Re: ***Final Drainage Report Revision 4, Cherokee WRF Total Dissolved Solids Reduction Facility***

**Cherokee TDS Reduction
Project No. 119416
Document No. LP-PLAT-RT-0002**

**Revision 4
9/20/2021**

PCD Filing No.: PPR-20-044

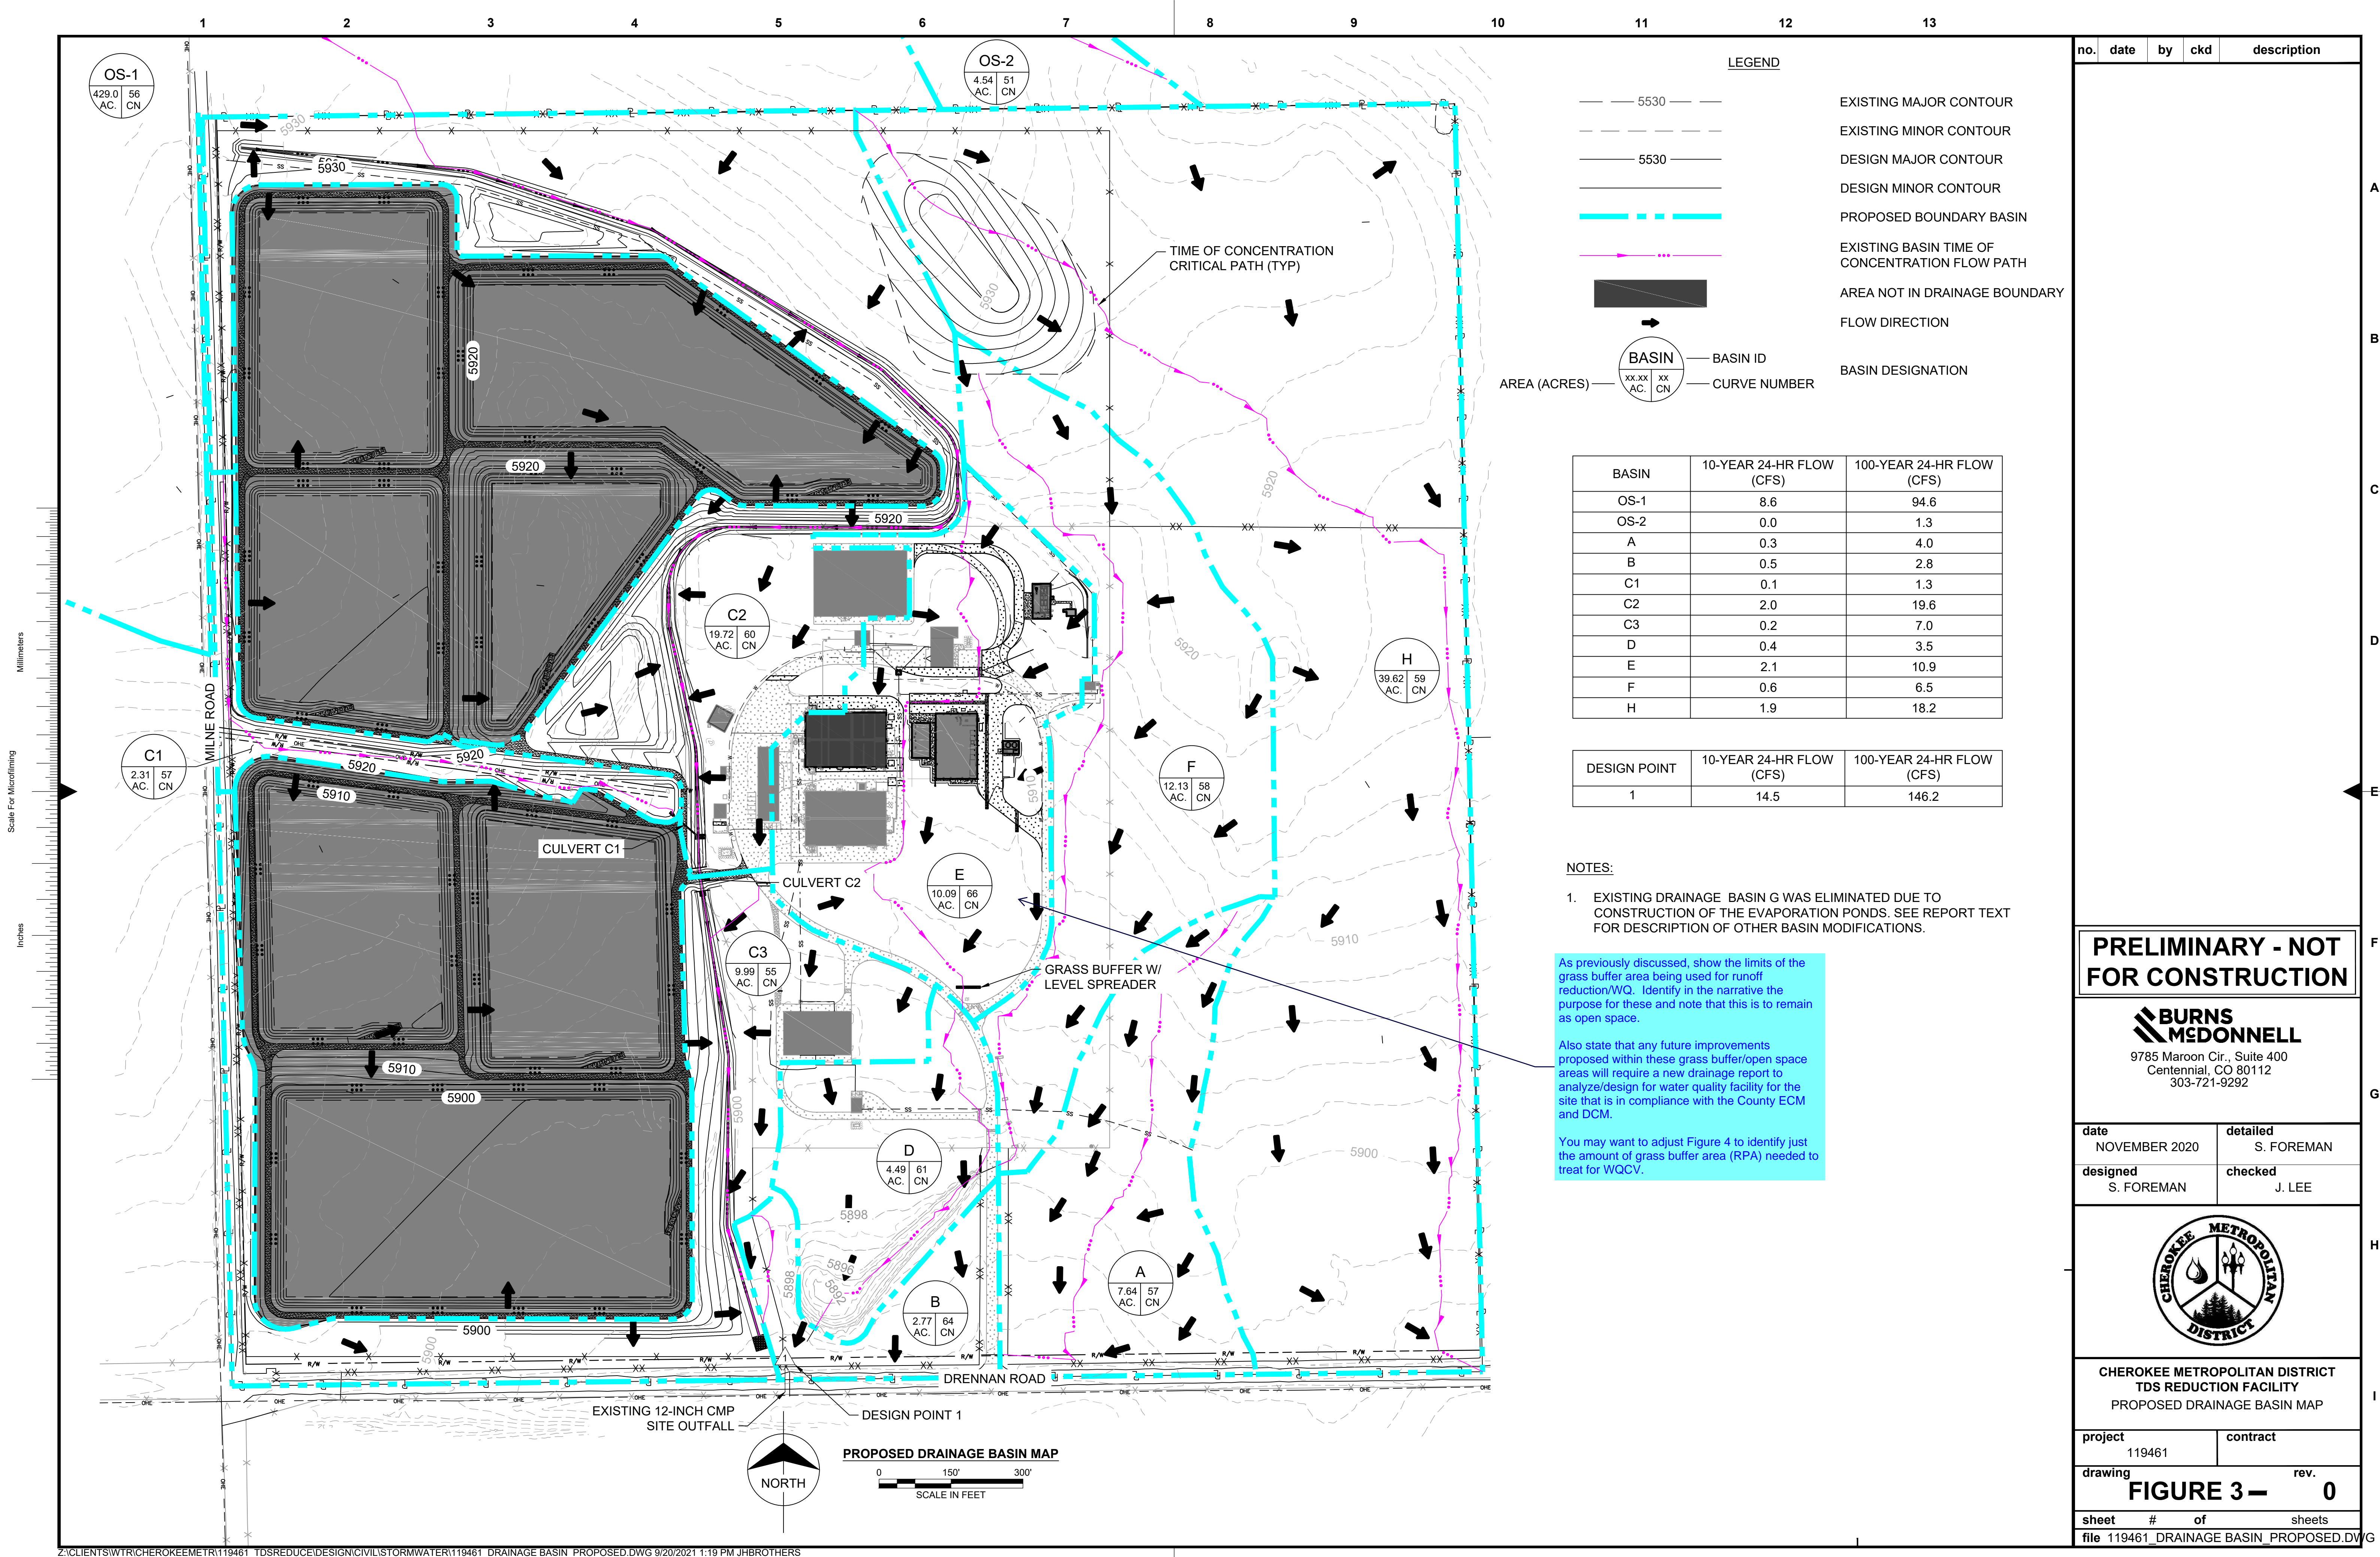
Provide a summary of the Runoff Reduction Calculation results

As previously discussed, show the limits of the grass buffer area being used for runoff reduction/WQ. Identify in the narrative the purpose for these and note that this is to remain as open space.

You may want to adjust Figure 4 to identify just the amount of grass buffer area (RPA) needed to treat for WQCV.
